GEN-2014-001 Modification Request Impact Study

Revision R1 August 3, 2023

Submitted to
Southwest Power Pool

Figure 2-2: GEN-2014-001 Single Line Diagram (Modification Configuration)

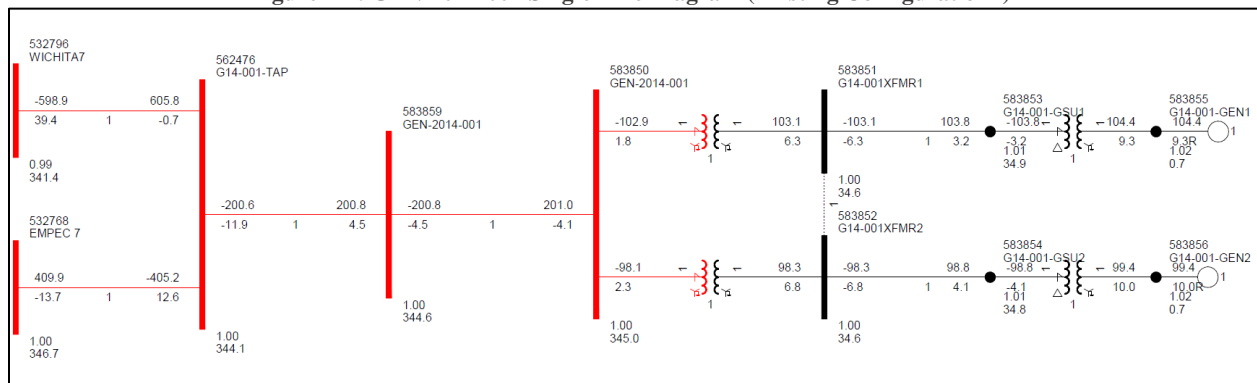
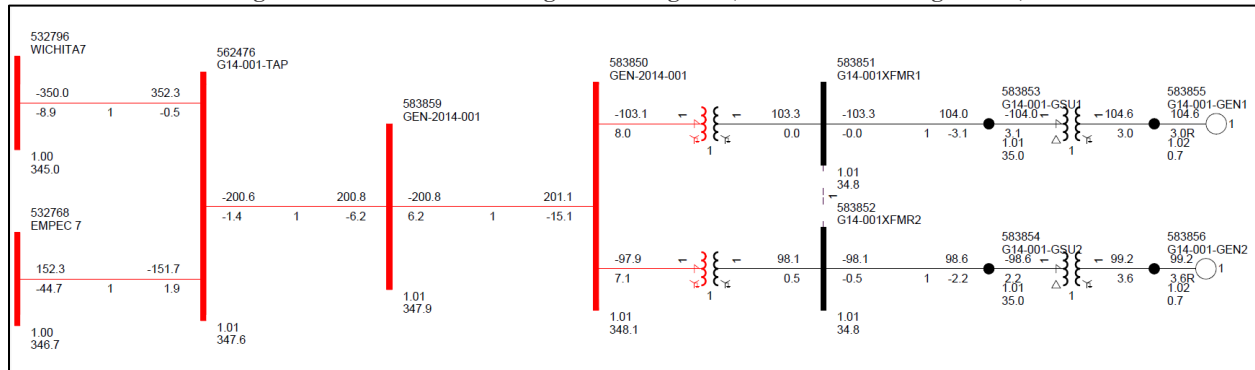
This Study has been requested by the Interconnection Customer to evaluate the modification of GEN-2014-001 to replace one of the main power transformers but keep the existing turbine configuration of 76 x GE 2.82 MW for a total capacity of 214.32 MW. This generating capability for GEN-2014-001 (214.32 MW) exceeds its Generator Interconnection Agreement (GIA) Interconnection Service amount, 200.6 MW, as listed in Appendix A of the GIA. As a result, the customer must ensure that the amount of power injected at the POI does not exceed the Interconnection Service amount listed in its GIA. The project includes the use of a Power Plant Controller (PPC) to limit the total power injected into the POI.

In addition, the modification request included changes to the generation interconnection line rating. Figure 2-2 shows the power flow model single line diagram for the GEN-2014-001 modification. The existing and modified configurations for GEN-2014-001 are shown in Table 2-1.

SPP determined that the change in impedance (3.38%) was not significant enough to impact the previously studied stability and short circuit results. Therefore, dynamic stability analysis and short circuit analysis were not required.

Figure 4-1: GEN-2014-001 Single Line Diagram Shunt Sizes (Modification)

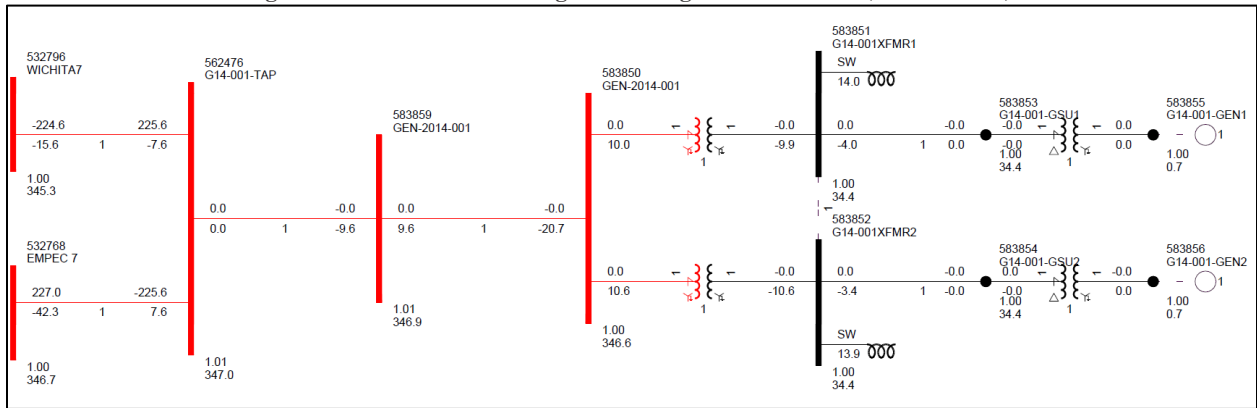
The results from the analysis showed that the GEN-2014-001 project needed approximately 28.08 MVAR of compensation at its project substation to reduce the POI MVAR to zero. This is a decrease from the 28.3 MVAR found in the previous modification study⁵. Figure 4-1 illustrates the shunt reactor size needed to reduce the POI MVAR to approximately zero with the updated topology. The final shunt reactor requirements for GEN-2014-001 are shown in Table 4-1.
